# DEVELOPMENT REVIEW COMMITTEE (DRC) COMMENT REPORT

**PROJECT NAME:** AQUÍ Bar and Kitchen

**CASE NUMBER:** UDP-S23022

**REQUEST:** Site Plan Level II Review: Change of Use from 1,406 Square-Foot of Office Use to Restaurant Use, 1,735 Square-Foot of New Outdoor Dining, and 965 Square-Foot of Temporary Food Trailers in Downtown Regional Activity Center

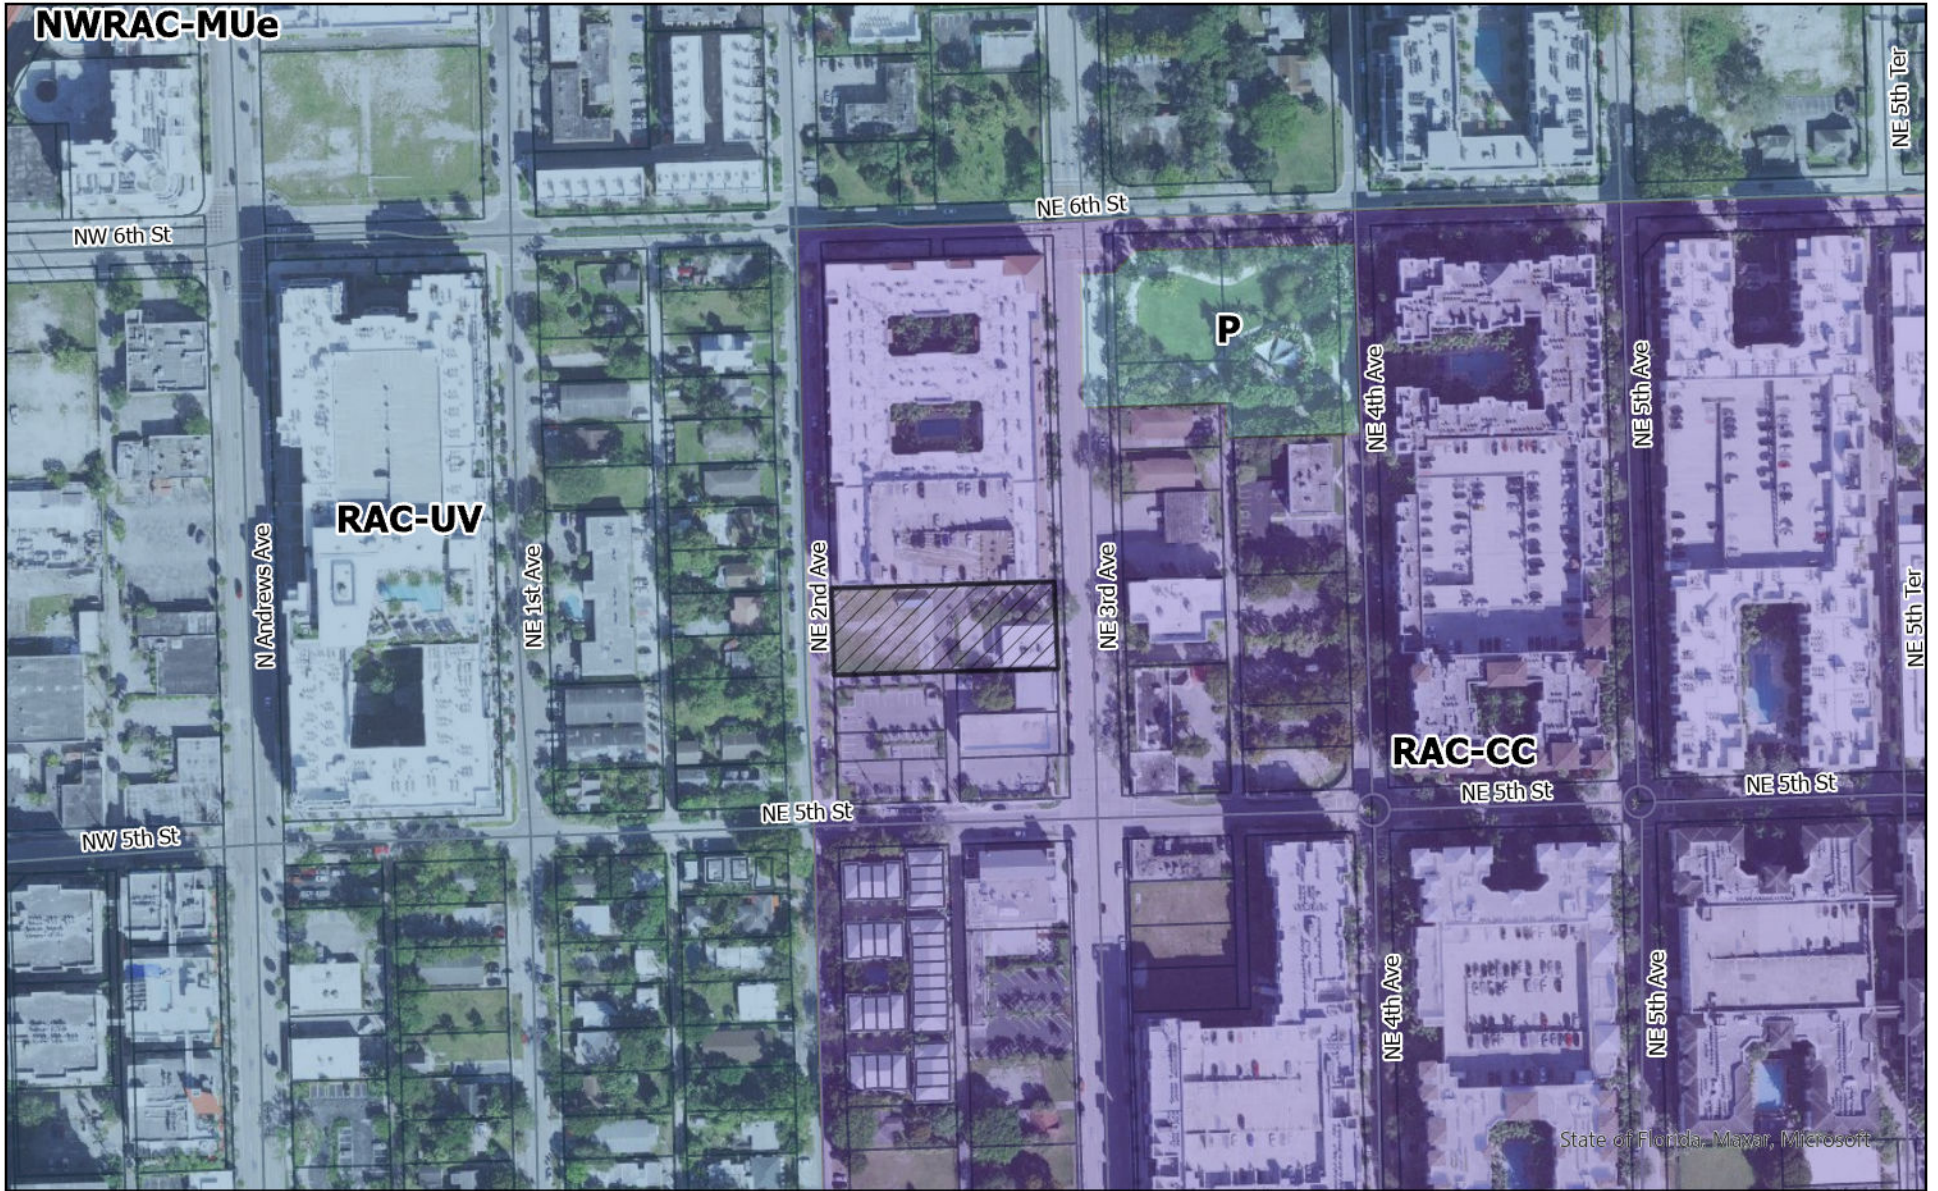
11. Provide a narrative to detail what will be done in the vacant part of the property that is delineated as not in scope on the site plan.
12. Provide the NE 3<sup>rd</sup> Avenue cross section for the portion of property facing NE 3<sup>rd</sup> Avenue. Please provide an adequate landscape strip with adequate shade trees between the curb and a clear 7-foot wide pedestrian path to provide a safer, more usable and comfortable pedestrian environment. See image below:
